City Council

REGULAR AGENDA OF JULY 15, 2024

1. PPZ2024-0279 T.J.B. Incorporated, 33600 Liberty Parkway, PPN 07-00-008-115-059

NORTH RIDGEVILLE PLANNING COMMISSION
MINUTES OF REGULAR MEETING
TUESDAY, JULY 9, 2024

Planning Commission Comment Sheet

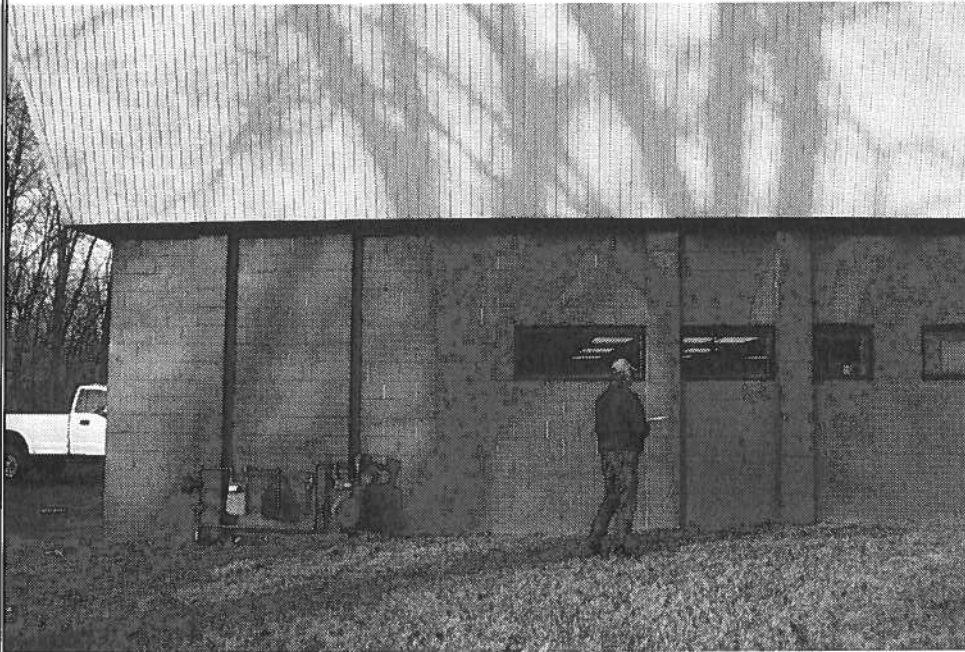
- Kim stated that they indicated that the addition was noted to be split face block and that there was going to be a metal roof. She mentioned that there was a color chart, but she wasn't sure what color they were proposing. Victor stated that the existing color was chocolate brown and that they were going to match that and would use standard blocks, which was what the rest of the building was. He said that they would be using dry block and would not take on any water. Kim asked that they update the final plans to note the plain versus split face block.

- Kim mentioned seeing a slight discrepancy between the architectural site plan and the engineering site plan regarding optional pavers or compressed stone and that engineering showed concrete that went behind the building. Victor stated that they were allowing for the fire department access to the back of the building. Kim stated that concrete would be the preferred way to go.

A-3

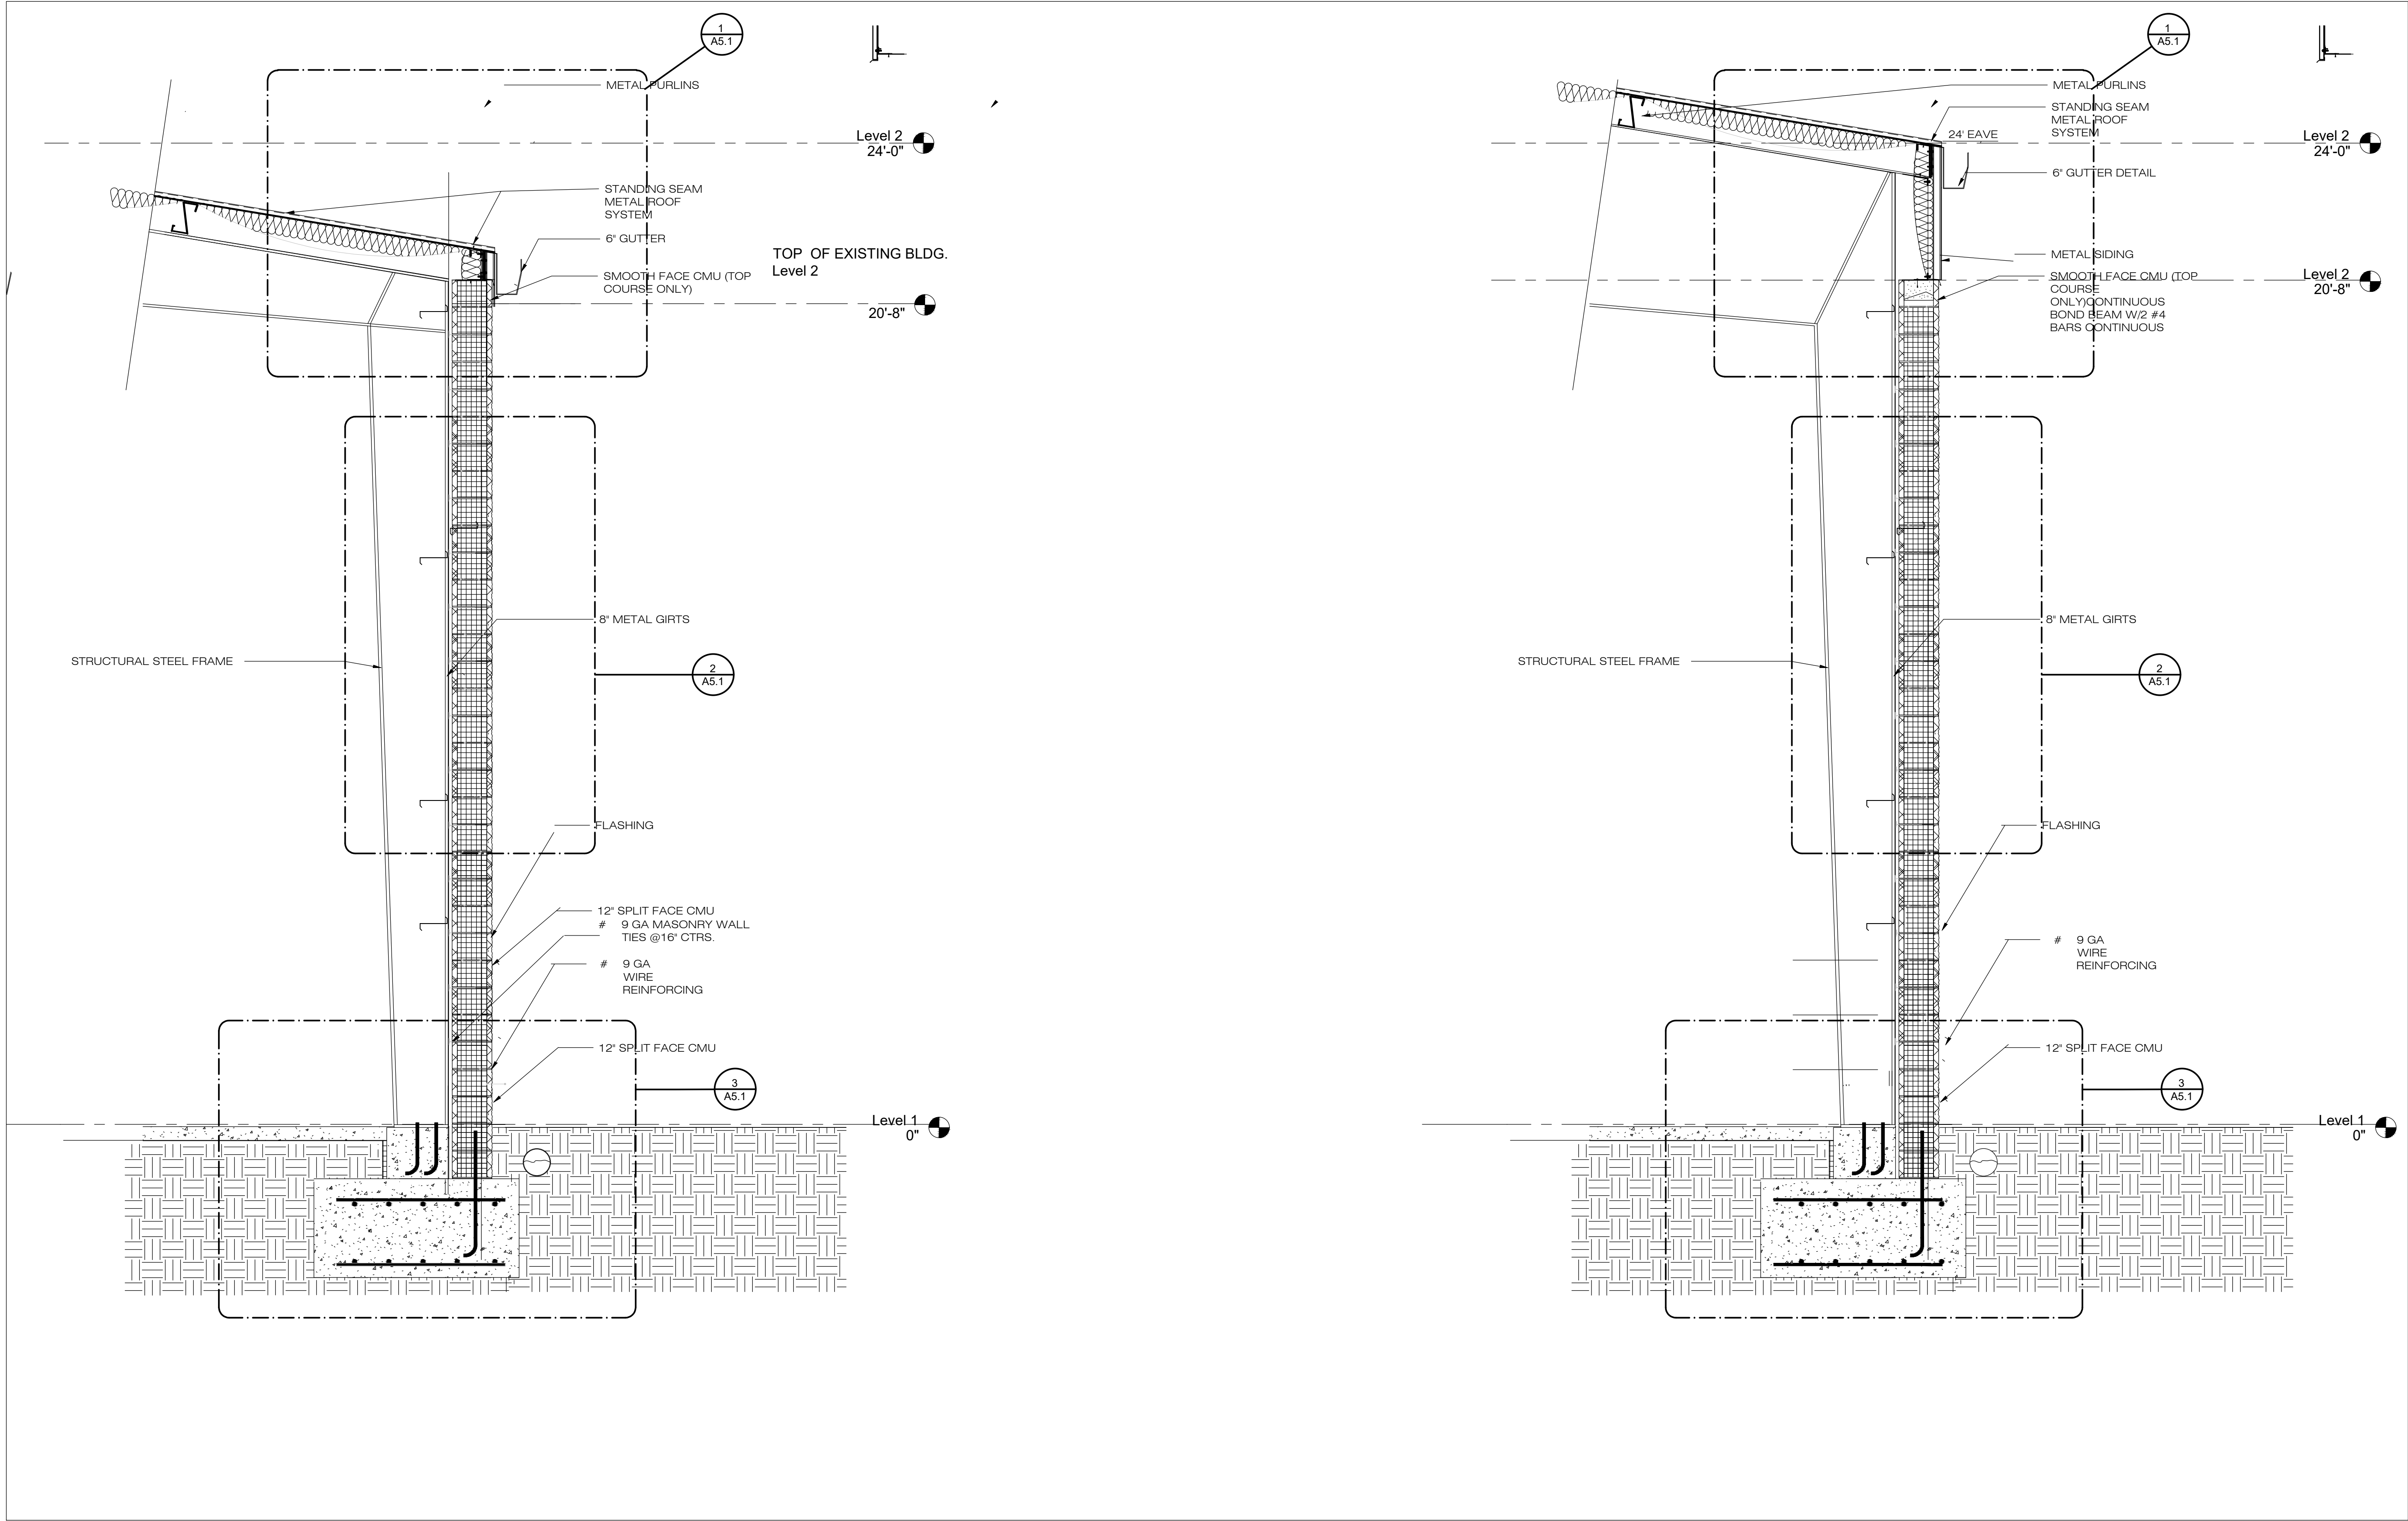
PC ACTION: Approved by a vote of 4-0 with the condition of changing the split face block to painted flat block regarding the elevation.

Motion made by Graupmann and seconded by Ali to approved application with the condition to change the split face block to flat painted block, regarding the elevation.
